June 27, 2019

**BOARD OF COUNTY COMMISSIONERS  
ORANGE COUNTY, FLORIDA  
IFB NO. Y19-767-TA/ ADDENDUM NO. 2**

**FORCE MAIN SOUTH AREA PACKAGE 2**

SCALE: AS SHOWN  
DRAWING NO.: **C-101**  
SHEET: 9 OF 17

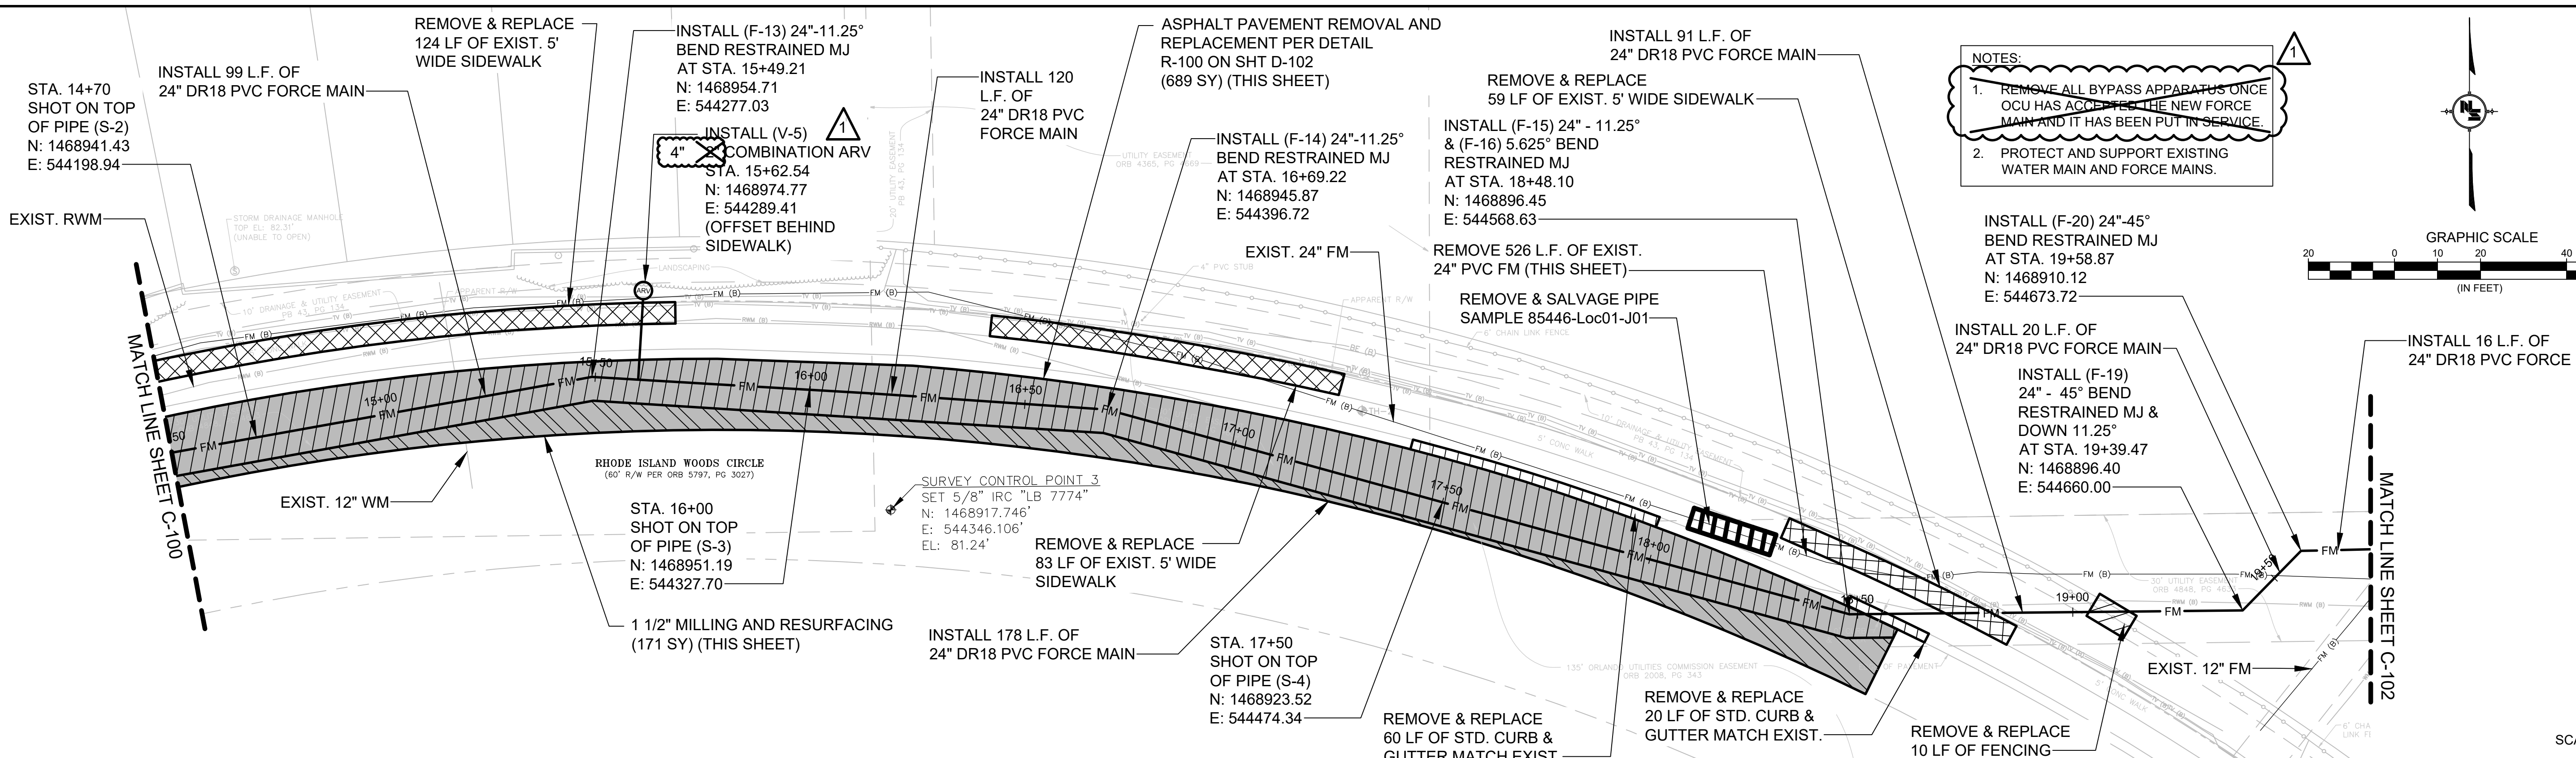
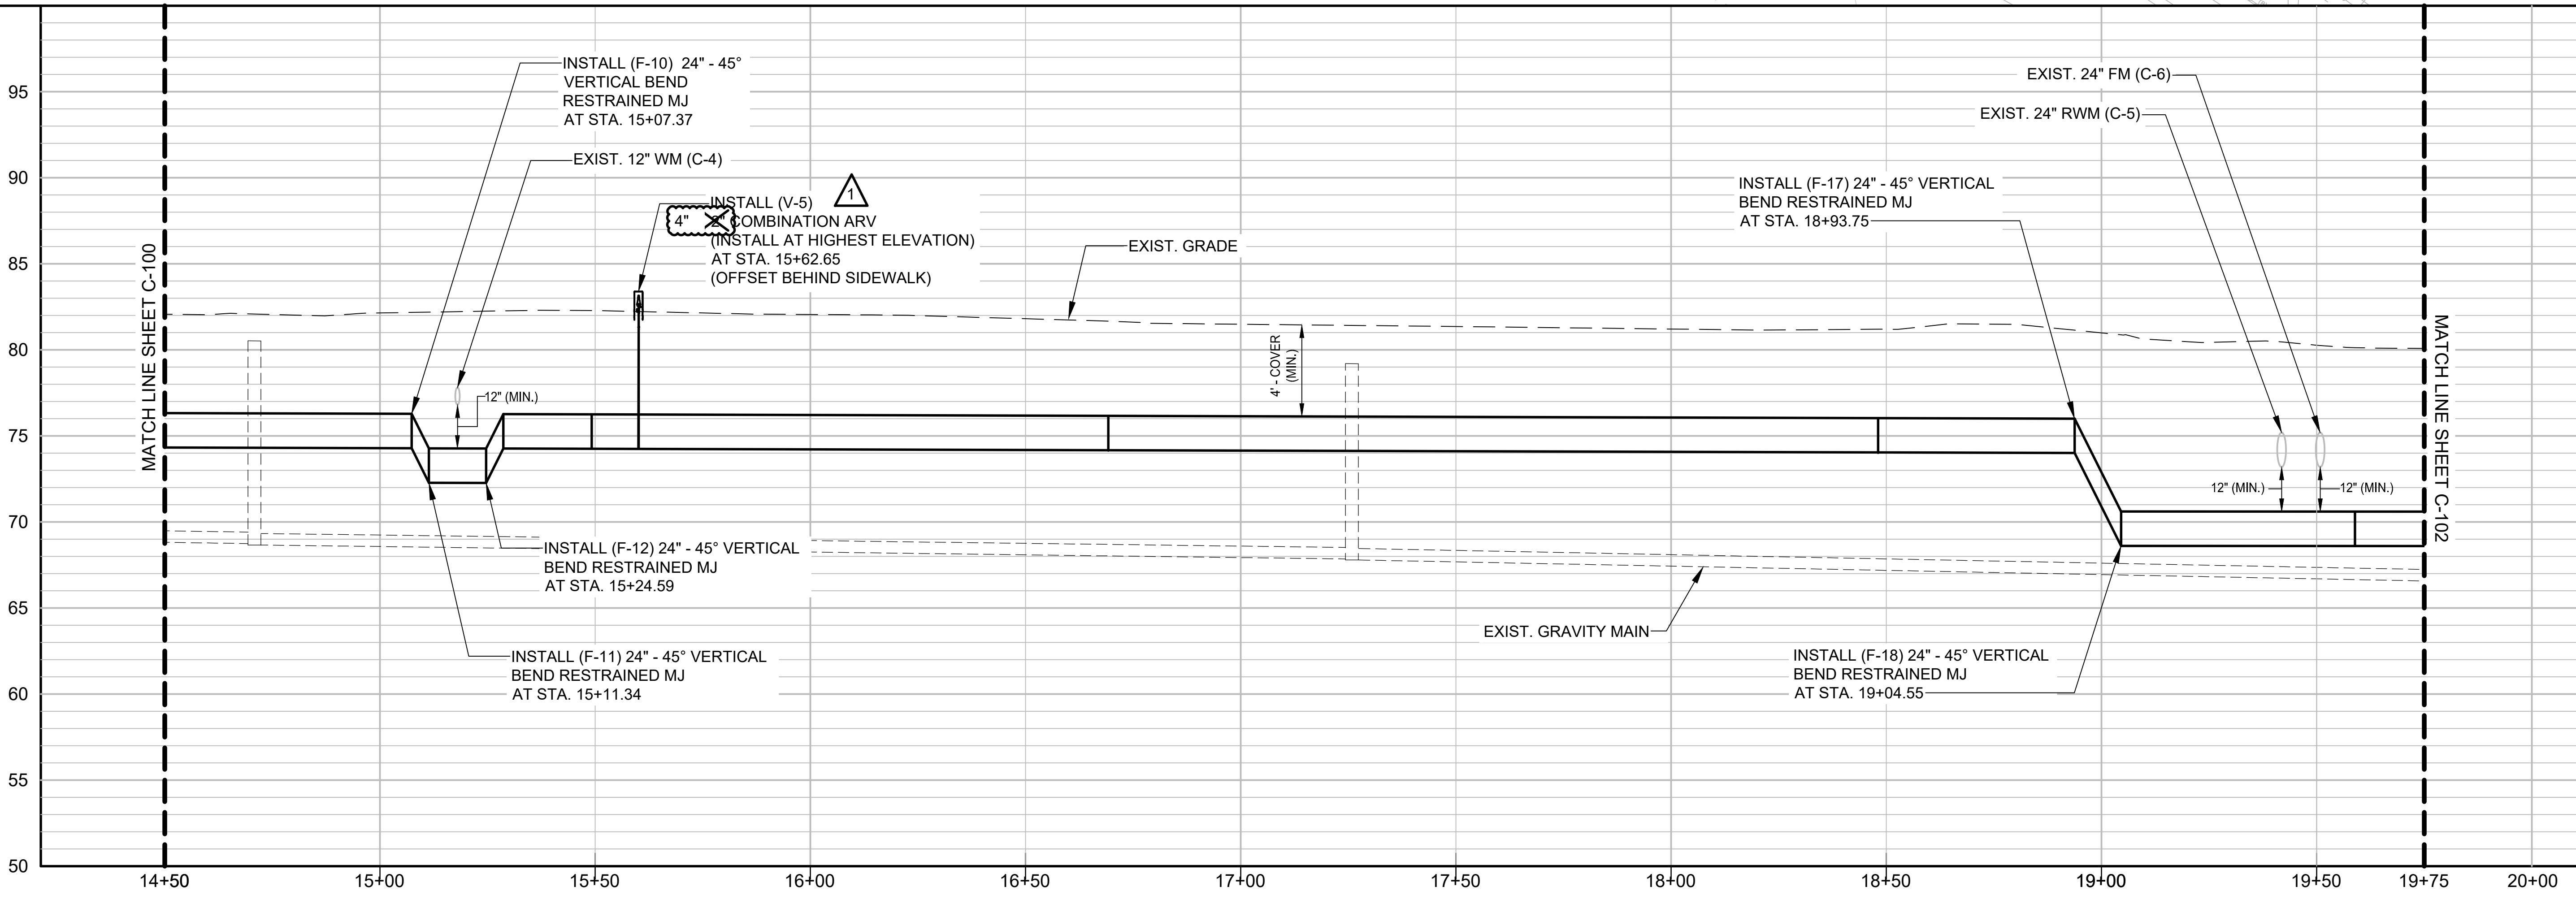
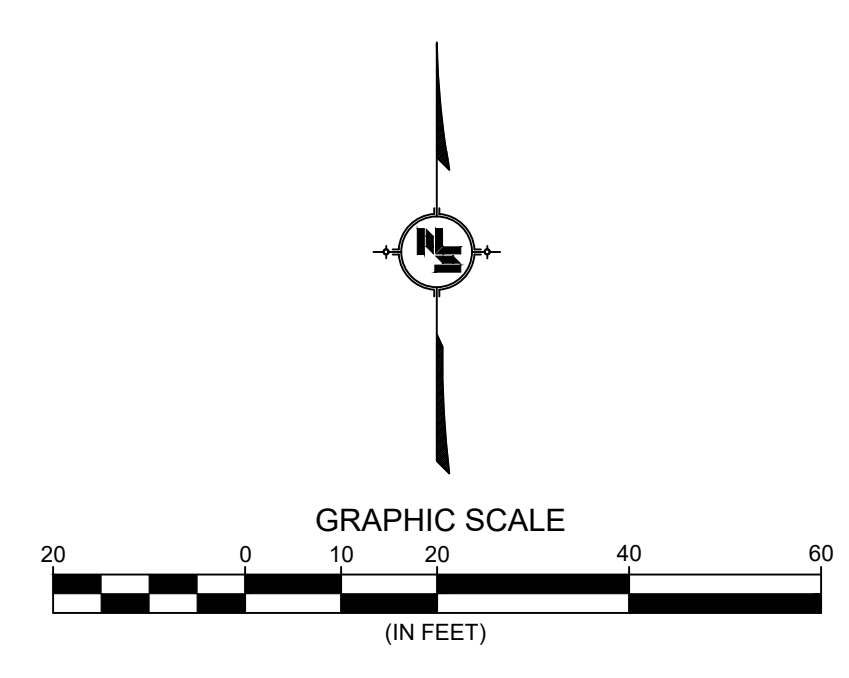
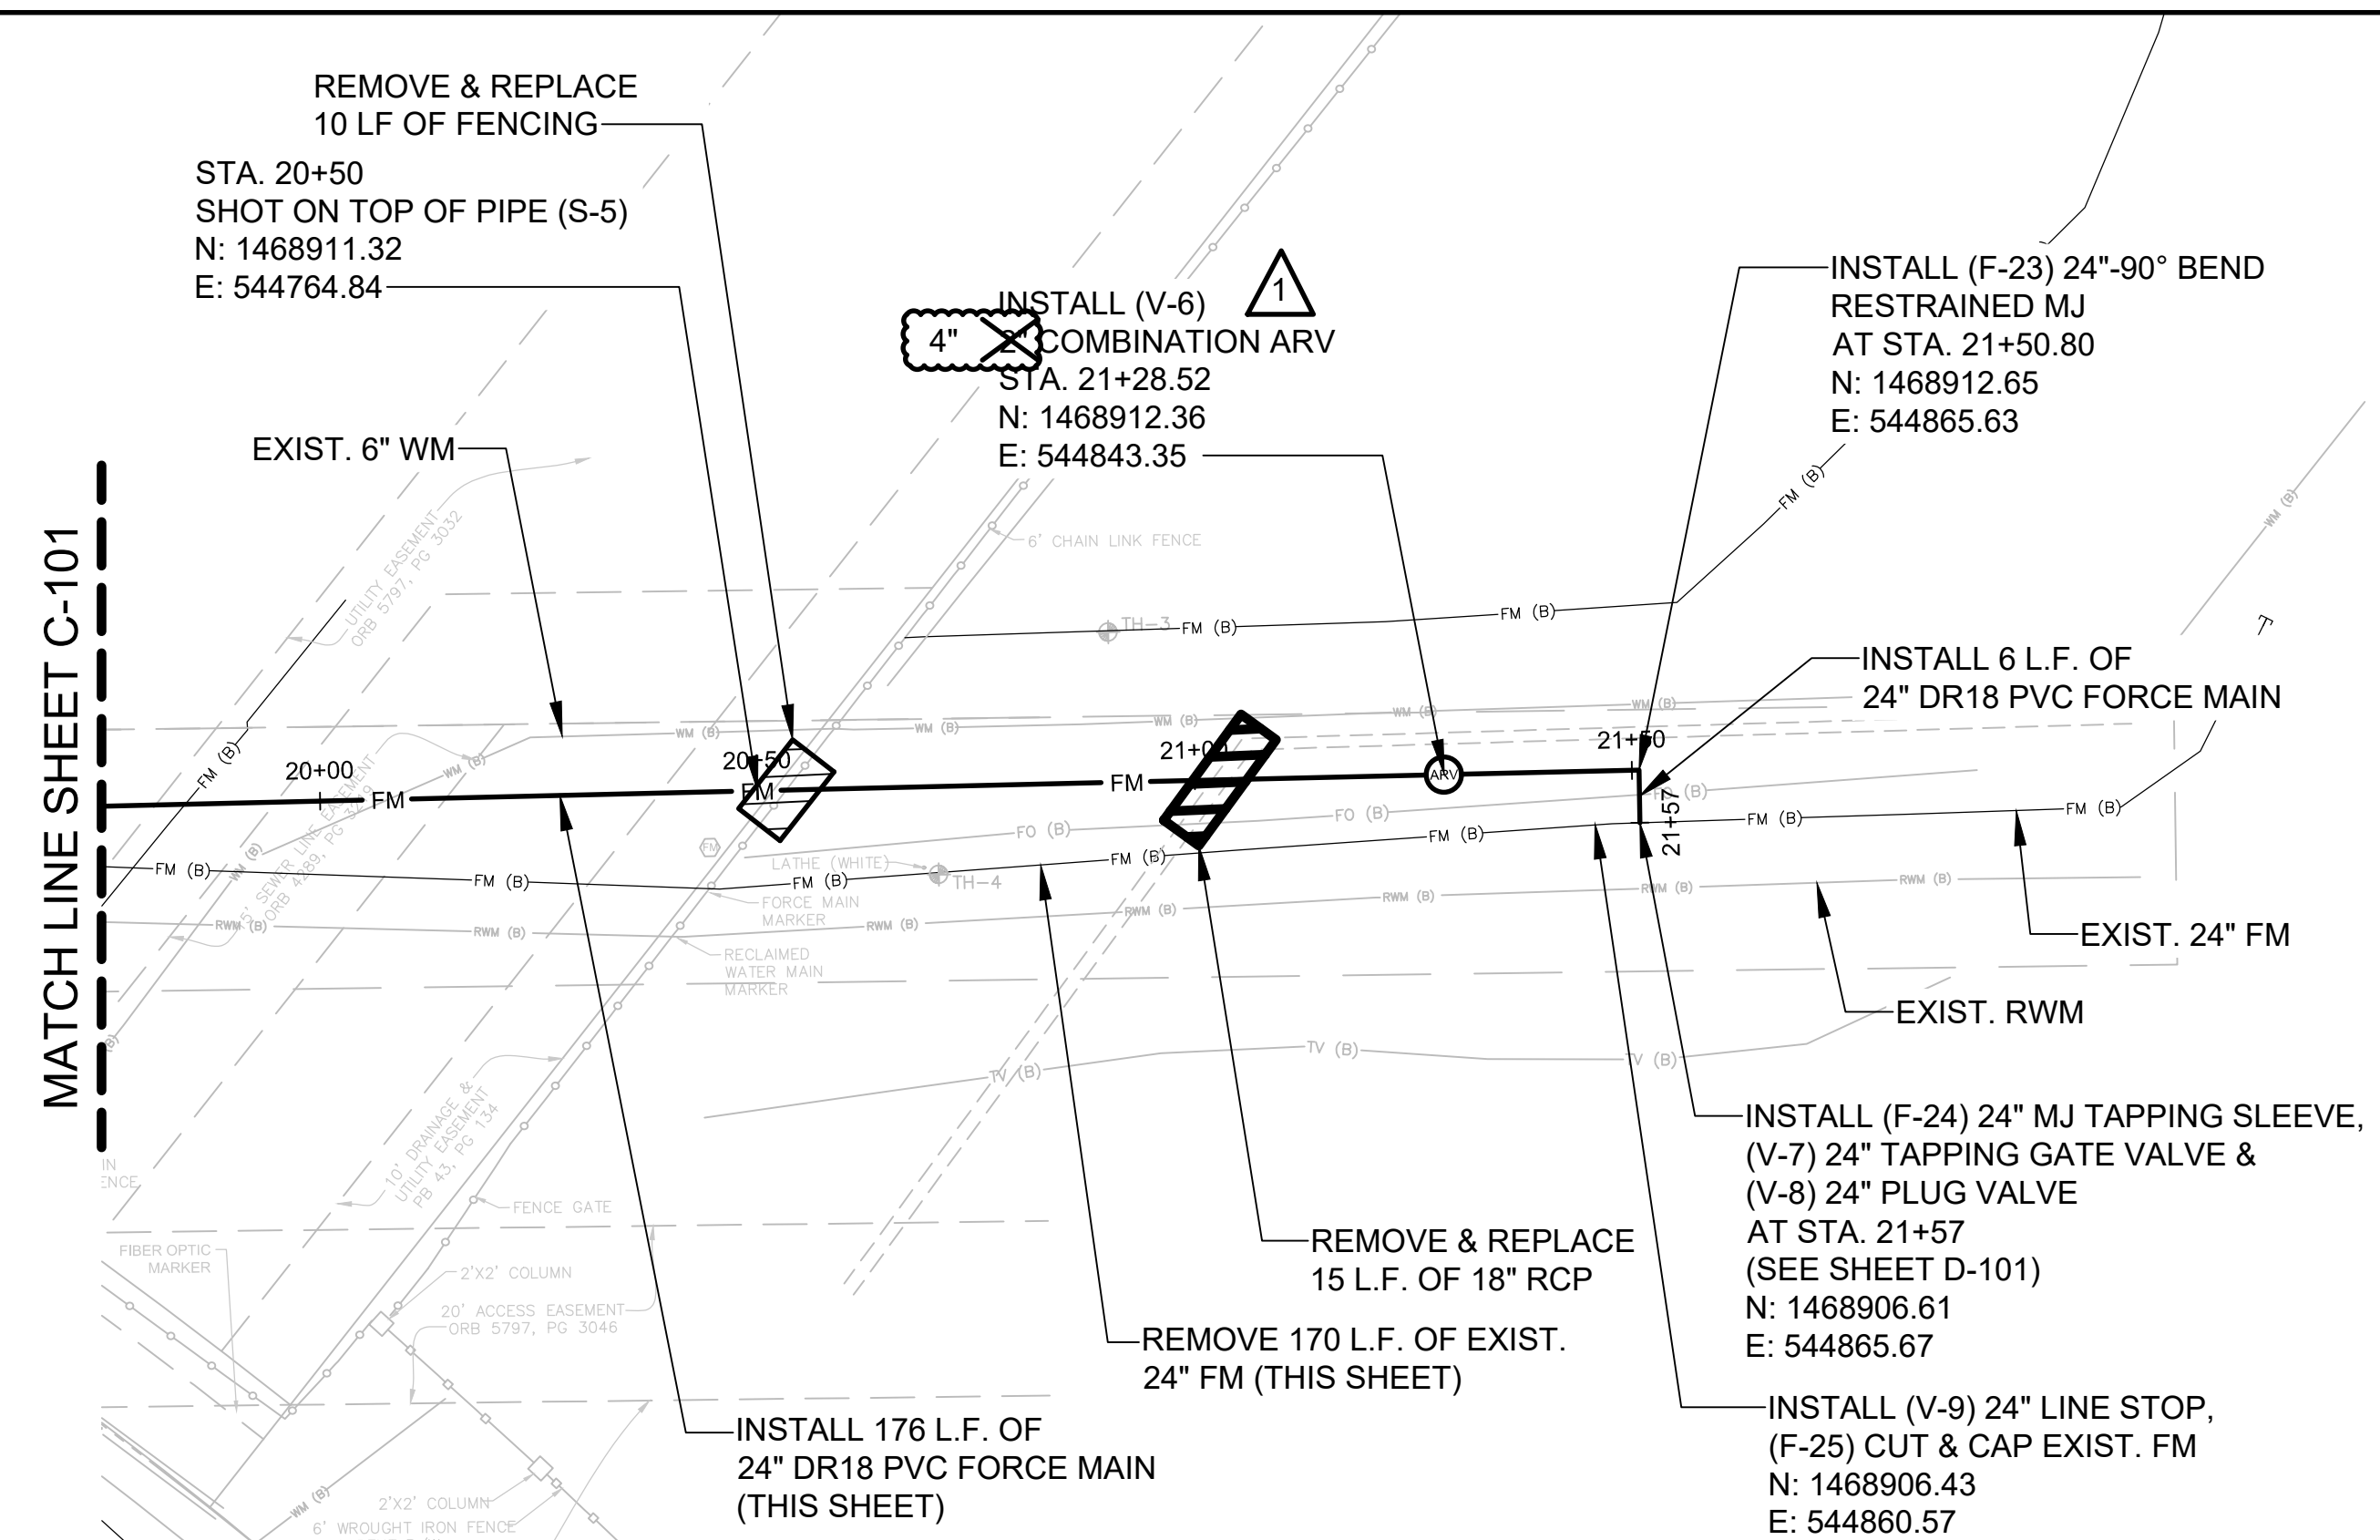
A: Bypass note has been deleted from sheets C100-C102 and C200-C201

- a. **Removal of Bypass note on sheets C-100, C-101, C-102, C-200 and C-201.**
- b. **Revision of ARV size on sheets C-100, C-101 and C-102.**
- c. **Revision of valve size V-13 on sheet X-100.**
